Access Compliance Report

Public Rights-of-Way

Intersection ID: 28317	Main Street: ANDREA_WY	Cross Street: ZACKERY_AV	Location: NW
ADA ID: DC2700D59F72	Ramp Type: BlendTrans2	Initial Pass/Fail: Fail	Overall Compliance: No
		Severity Score: 8.75

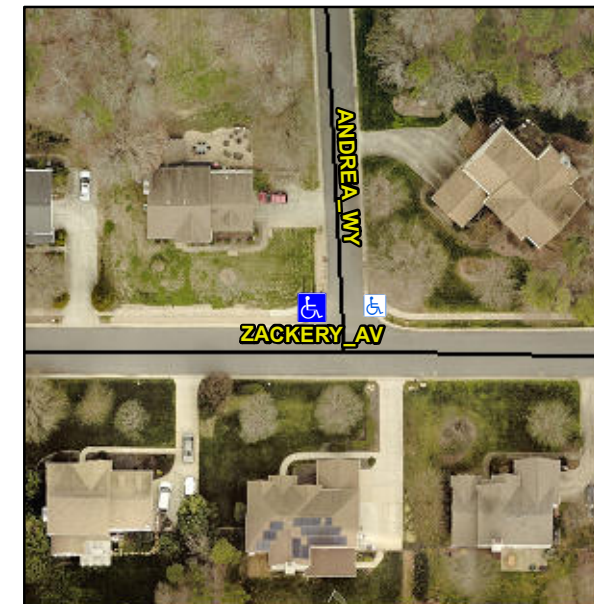
Not Found, R304.5.1

Compliance	Description	Data	Compliance	Description	Data
N/A	Ramp Length (in)	96.0	Yes	BlendTrans Slope (%)	4.6
No	Ramp Width (in)	46.0	Yes	BlendTrans XSlope (%)	0.5
N/A	Flare Type LT	N/A	N/A	Flare Type RT	N/A
N/A	Flare Slope LT (%)	N/A	N/A	Flare Slope RT (%)	N/A
N/A	Flare Traversable LT?	N/A	N/A	Flare Traversable RT?	N/A
N/A	Landing Length (in)	N/A	N/A	DWS Provided?	N/A
N/A	Landing Width (in)	N/A	N/A	DWS Contrast?	N/A
N/A	Landing Slope (%)	N/A	N/A	DWS Length (in)	N/A
N/A	Landing X Slope (%)	N/A	N/A	DWS Full Width?	N/A
N/A	Landing Curb? (Y/N)	N/A	N/A	DWS Offset (in)	N/A
N/A	Shared Landing?	N/A			
N/A	Gutter Ponding?	Yes	N/A	Gutter Slope (%)	N/A
N/A	Gutter Lip Ht (in)	N/A	N/A	Gutter X Slope (%)	N/A
N/A	Painted X Walk1?	No	N/A	Painted X Walk2?	No
	X Walk 1 Direction	To S		X Walk 2 Direction	To E
	X Walk 1 Width (in)	N/A		X Walk 2 Width (in)	N/A
	X Walk 1 Slope (%)	3.0		X Walk 2 Slope (%)	0.3
	X Walk 1 X Slope (%)	0.3		X Walk 2 X Slope (%)	1.4

N/A	Ramp inside XWalk1?	N/A	N/A	Ramp inside XWalk2?	N/A
	Road Slope (%)	0.1		Clear Space?	N/A
	Road X Slope (%)	3.7	N/A	Clear Space to XWalk (in)	N/A
N/A	Any Obstructions?	N/A	N/A	Storm Grate/Utility Hazard?	N/A
	Obstruction Type			Storm Grate/Utility Type	
		N/A			N/A
		Yes		Surface Condition? (G/P)	Good
		No		Curb Slope (%)	11.4

Remove & Replace Curb Ramp With Two New Directional Ramps or Equivalent.
